LR-N15-0124
LAR S15-02

Salem Nuclear Generating Station Units 1 and 2
Renewed Facility Operating License Nos. DPR-70 and 75
NRC Docket Nos. 50-272 and 50-311

Subject: Supplemental Information Needed for Acceptance of Requested Licensing Action
Re: Amendment Request Regarding Replacement of Source Range and
Intermediate Range Neutron Monitoring Systems (TAC Nos. MF6065 and
MF6066)

Figure 1

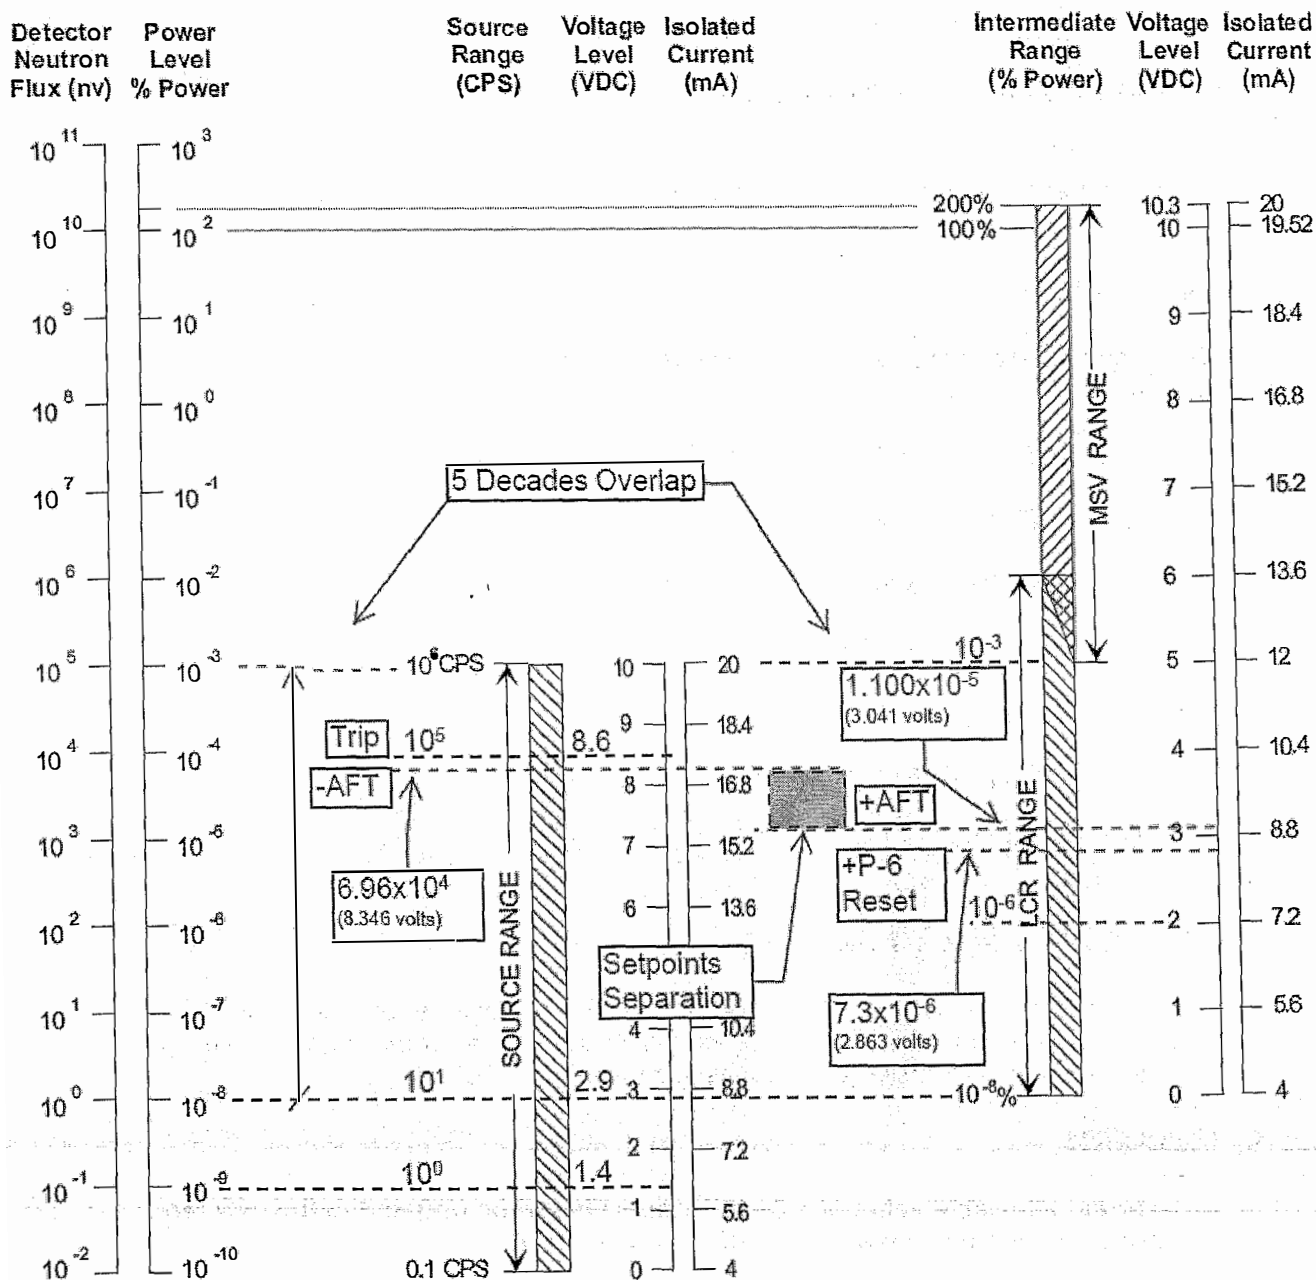
5. Item B on top of page 5 of attachment 1 to the license amendment request states, "Due to the changes in the IR detector output and units, an assessment was completed to verify adequate coordination between the P-6 setpoint and the SR neutron flux reactor trip setpoint for the Thermo Scientific instrumentation." Please provide a summary of this assessment for NRC staff review.

Section 3.7.1.3 of Enclosure 1 provides a discussion of the P-6 Interlock. Figure 1 of Enclosure 1 provides a graphical representation of the margin between the P-6 setpoint and the SR neutron flux reactor trip setpoint.

There is not a defined Analytical Limit (AL) for the P-6 Permissive reset setpoint. However, an adequate separation between the Source Range Setpoint decreasing value and the P-6 Reset increasing value exists as presented in Figure 1.
